Validation report form for renewal of crediting period for CDM project activities

VALIDATION REPORT FOR RENEWAL OF CREDITING PERIOD (RCP)

Title of the project activity	Longyou 18 MW Hydropower Project in Zhejiang Province
Reference number of the project activity	2142
Number and duration of the next crediting period	2 nd , 7 years (12/08/2016 to 11/08/2023)
Version number of the validation report for RCP	02
Completion date of the validation report for RCP	12/04/2016
Version number of PDD to which this report applies	Version 08
Project participant(s)	Zhejiang Longyou Xiaoxitan Hydro Complex Development Co., Ltd. China Carbon N.V.
Host Party	China
Sectoral scope(s), selected methodology(ies), and where applicable, selected standardized baseline(s)	Sectoral scope -1: Energy industries (renewable/non-renewable sources) Methodology - ACM0002 Version 16.0.0, Grid-connected electricity generation from renewable sources
Estimated annual average GHG emission reductions or net anthropogenic GHG removals in the next crediting period	56,474 tCO ₂ e

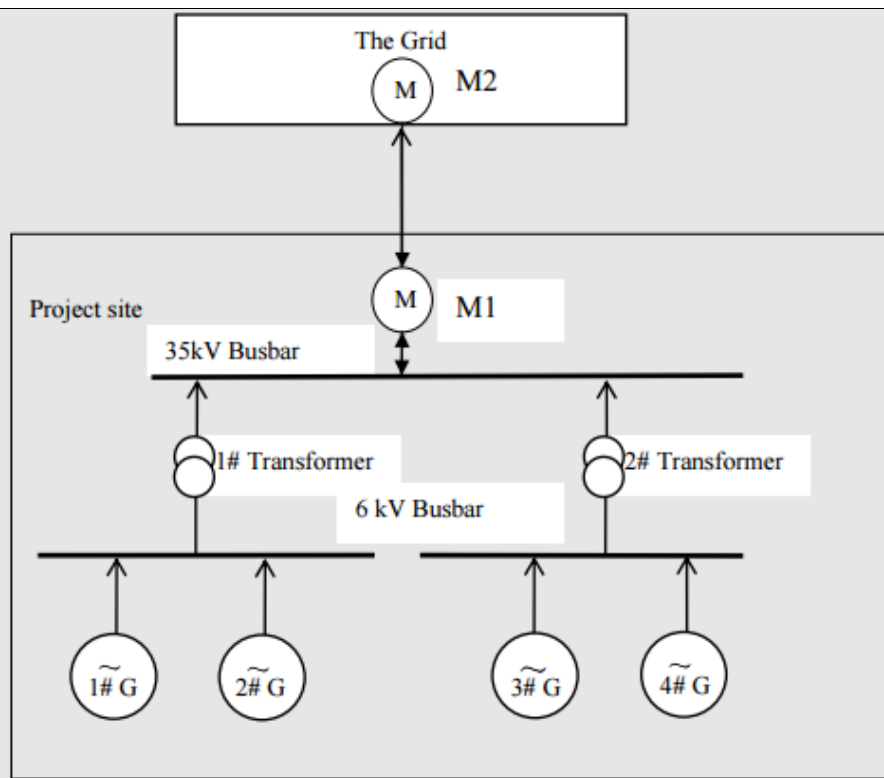
However, **CAR-3** was raised here as the ω_{OM} and ω_{BM} are incorrect in the PDD.

The PDD has been revised to correct the ω_{OM} and ω_{BM} , and information used in the Section B.6 and Appendix 4 has been updated as per the latest published “Notification on 2015 Baseline Emission Factors for Regional Power Grids in China” by China DNA. Then the **CAR-3** was closed.
